City of El Paso – City Plan Commission Staff Report

Case No:	SUSU13-00063 – Hill Terrace Addition Replat No. 1
Application Type:	Resubdivision Combination
CPC Hearing Date:	August 22, 2013
Staff Planner:	Nelson Ortiz, (915) 541-4931, ortiznx@elpasotexas.gov
Location:	East of US54 and North of Mobile
Acreage:	8.015 acres
Rep District:	2
Existing Use:	Vacant
Existing Zoning:	R-4 (Residential)
Proposed Zoning:	R-4 (Residential)
Nearest Park:	Park proposed within subdivision
Nearest School:	Coldwell Elementary School (0.44 mile)
Park Fees Required:	N/A
Impact Fee Area:	N/A
Property Owner:	City of El Paso
Applicant:	City of El Paso
Representative:	Brock & Bustillos

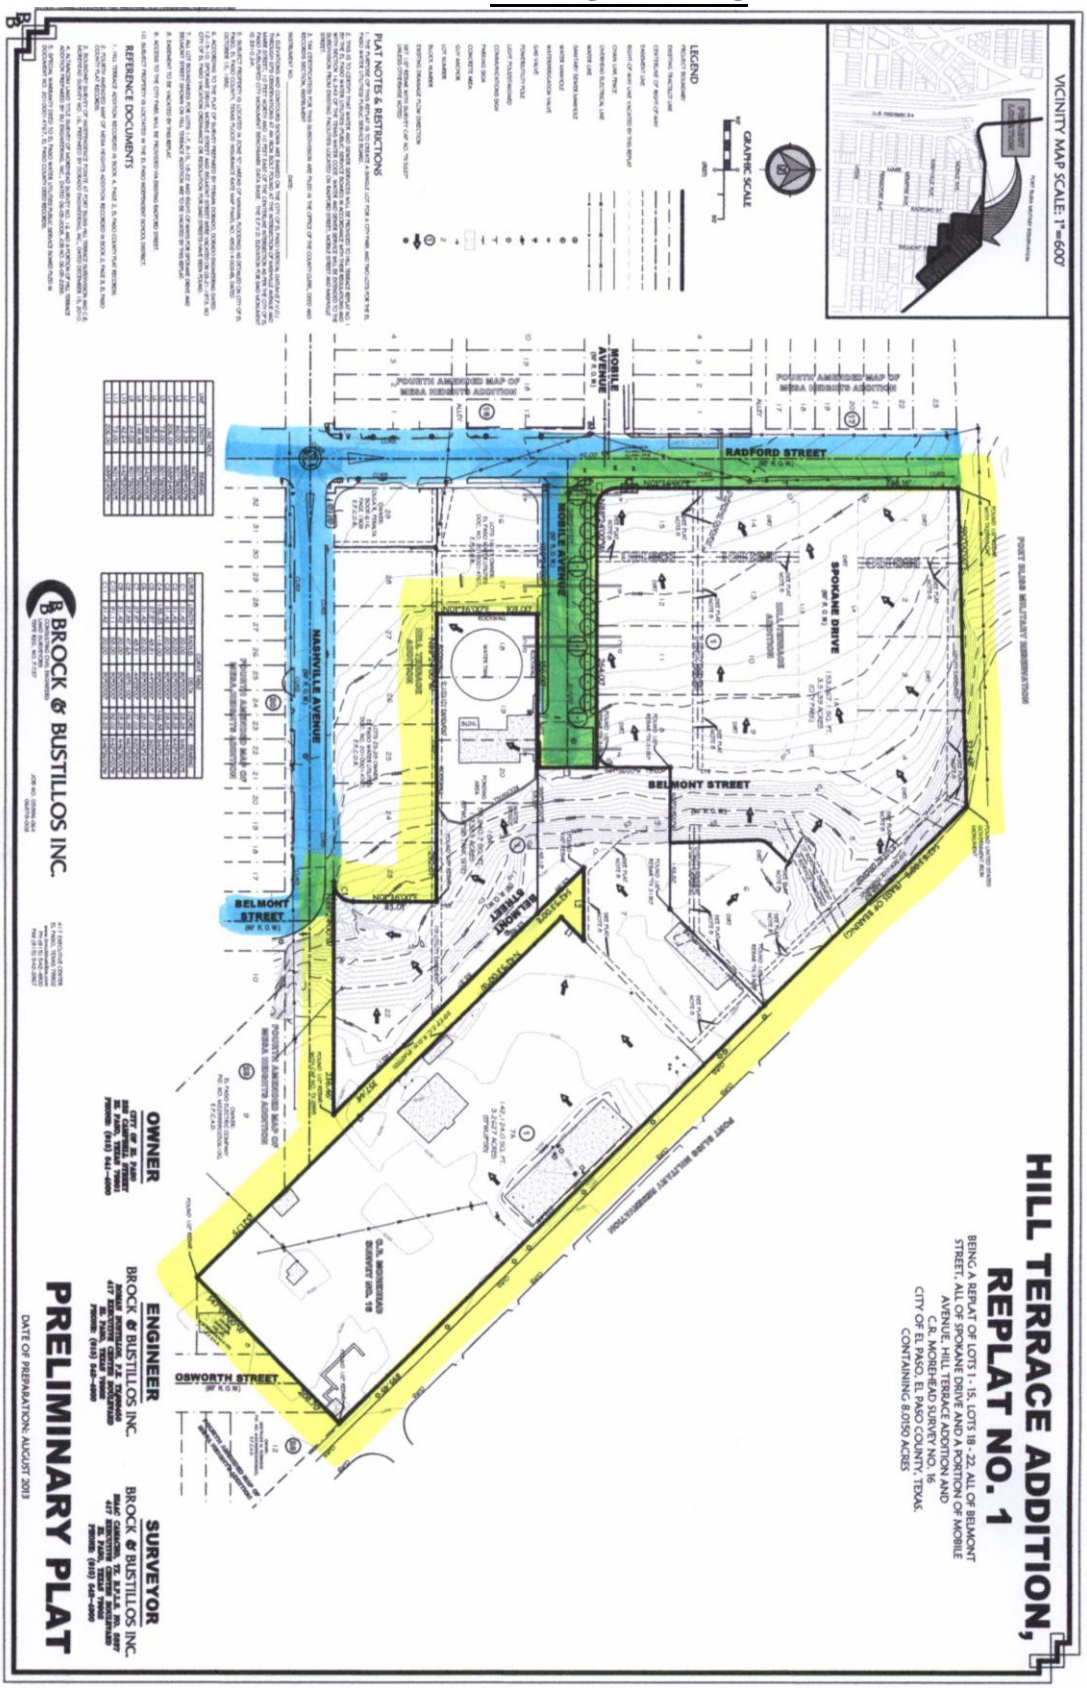
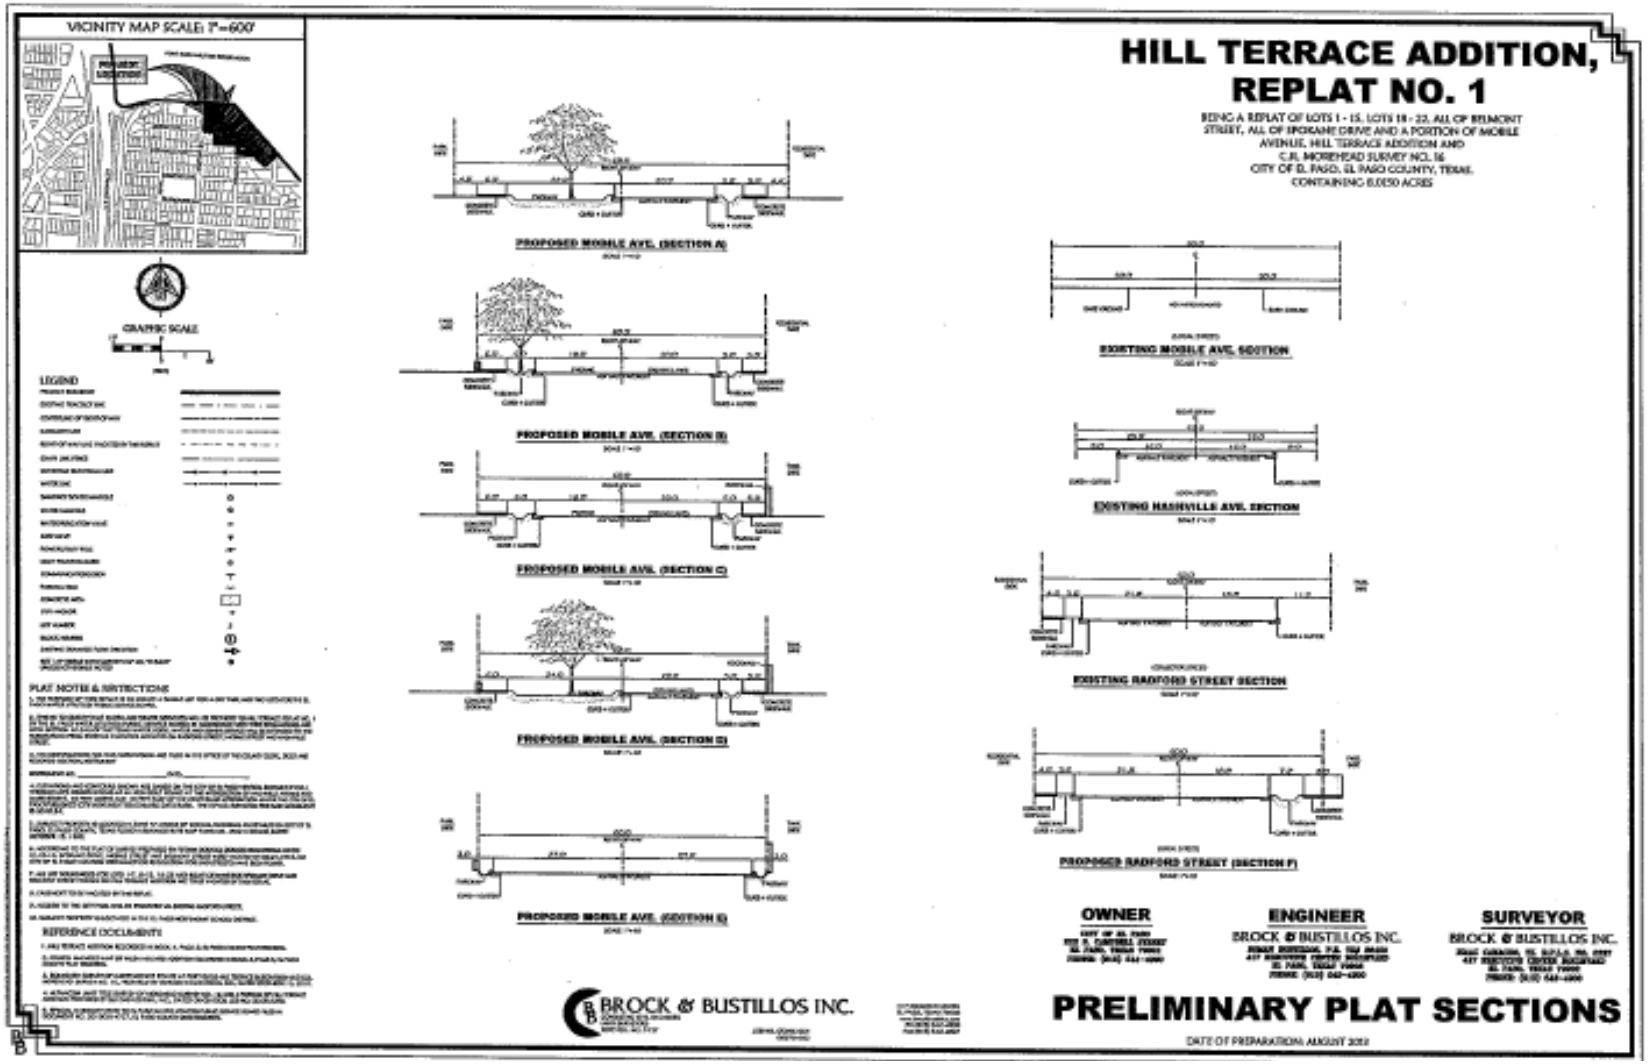
1. Include proposed drainage flow arrows on preliminary plat.
2. All developed storm water runoff shall be retained within the subdivision boundaries.

ATTACHMENT 4

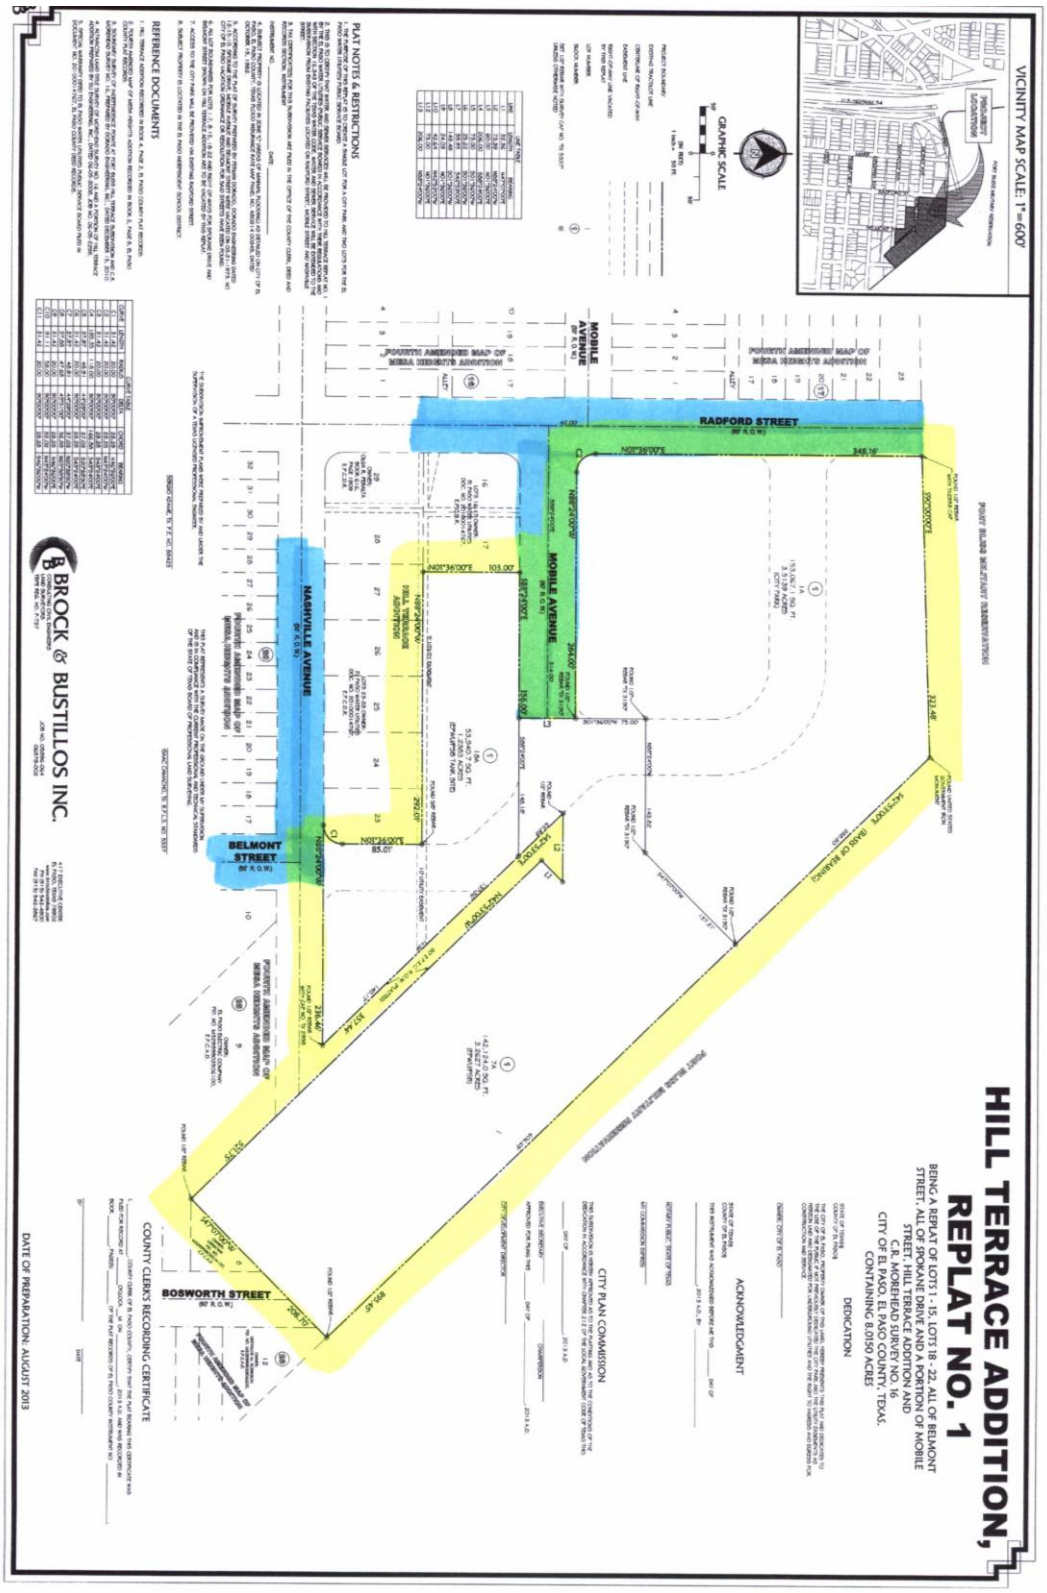
These submitted comments **shall** be clearly noted in the NOTES section of the re-plat.

Where required by the fire code official, fire apparatus access roads shall be marked with permanent NO

PARKING—FIRE LANE signs complying with Figure D103.6. Signs shall have a minimum dimension of 12 inches (305 mm) wide by 18 inches (457 mm) high and have red letters on a white reflective background. Signs shall be posted on one or both sides of the fire apparatus road as required by Section D103.6.1 or D103.6.2.
